Planning Local Review Body

3	Review of Case - Application P/19/0316 for Erection of 2 Storey Side Extension with Associated Alterations at 15 Reay Avenue, East Kilbride Report dated 3 December 2019 by the Executive Director (Finance and Corporate Resources). (Copy attached)	7 - 10
3a	Appendix 1 Planning Application Form	11 - 18
3b	Appendix 2 Report of Handling	19 - 28
3c	Appendix 3 Site Photographs and Location Plan	29 - 36
3d	Appendix 4 Planning Decision Notice and Reasons for Refusal	37 - 44
3e	Appendix 5 Notice of Review	45 - 72
3f	Appendix 6 Further Representations	73 - 82

Report to:Planning Local Review BodyDate of Meeting:16 December 2019Report by:Executive Director (Finance and Corporate Resources)

Application Type:	Detailed Planning Permission	
Applicant:	D Haughey	
Proposal:	Erection of 2 Storey Side Extension with Associated Alterations	
Location: Council Area/Ward:	15 Reay Avenue, East Kilbride, G74 1QT 08 East Kilbride Central North

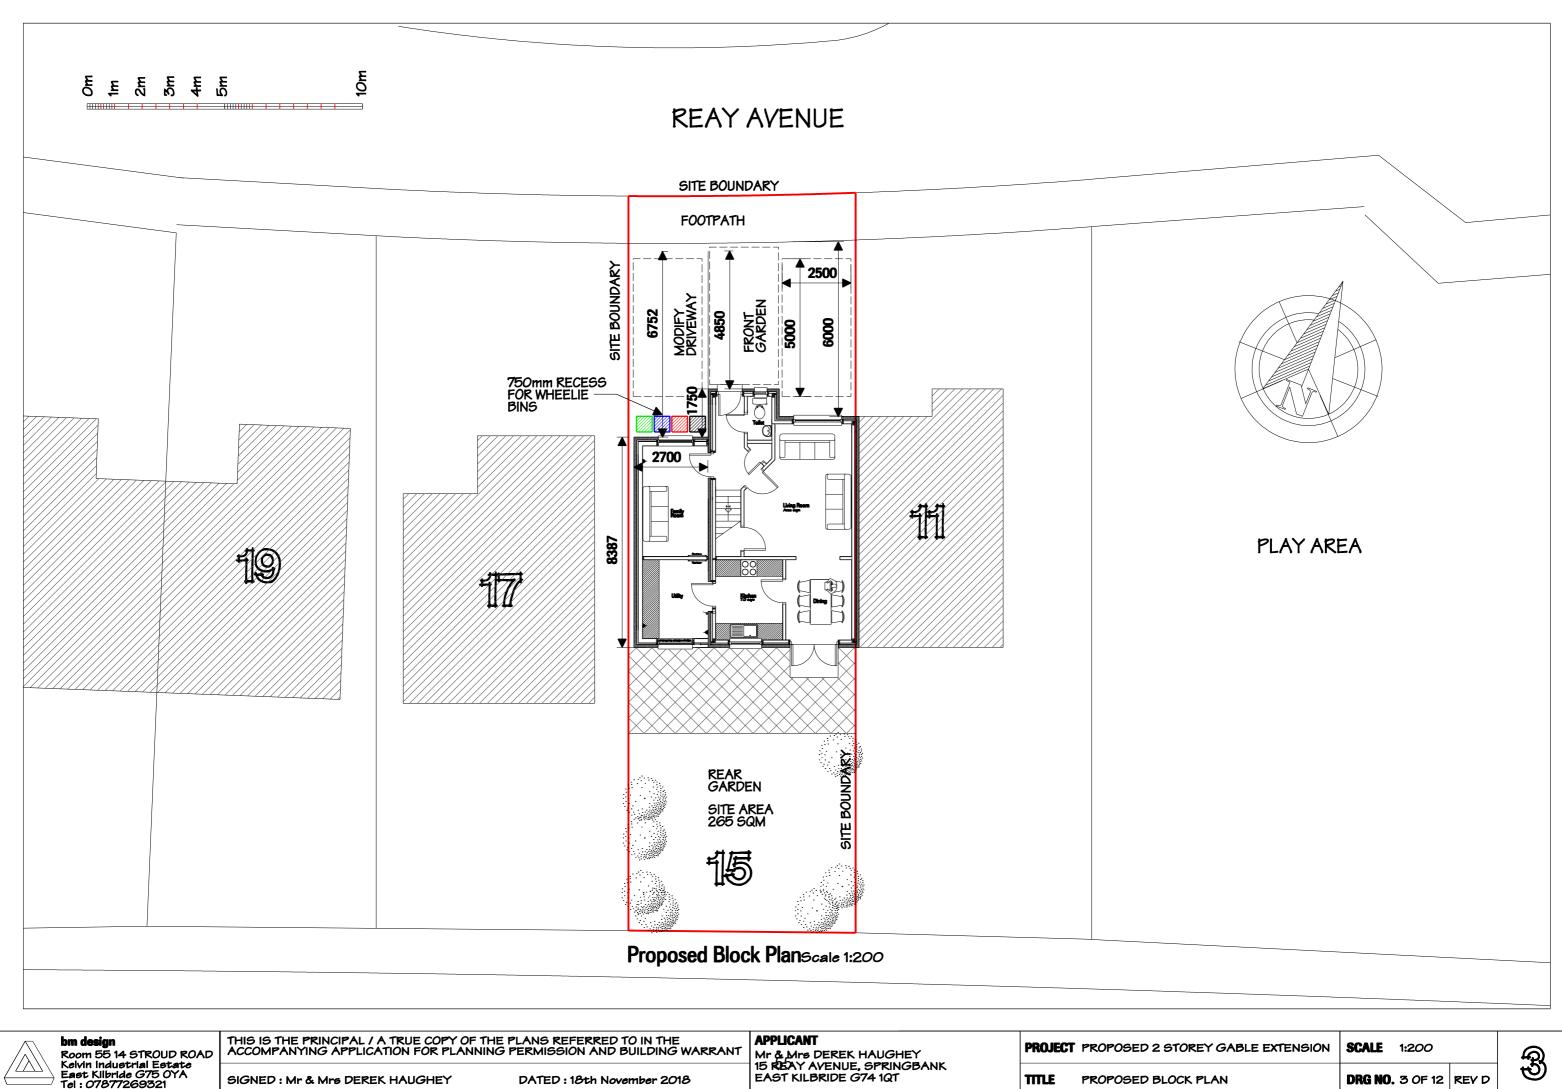
• The Proposals are to enhance the living accommodation for a family of two adults and two teenage children, not to create additiona sleeping accommodation. As a result, we have amended the plans to accommodate 2 car parking spaces on the hard-landscaped

amenity to the front of the property. The provision of which is not uncommon throughout East Kilbride to provide additional parking facilities to properties and also enhance the property by providing a low maintenance amenity space for the occupiers.

• The revised planning application drawings show that the bin storage area will be recessed back from the original property building line and will be screened to minimise the aesthetic impact to the front of the dwelling.
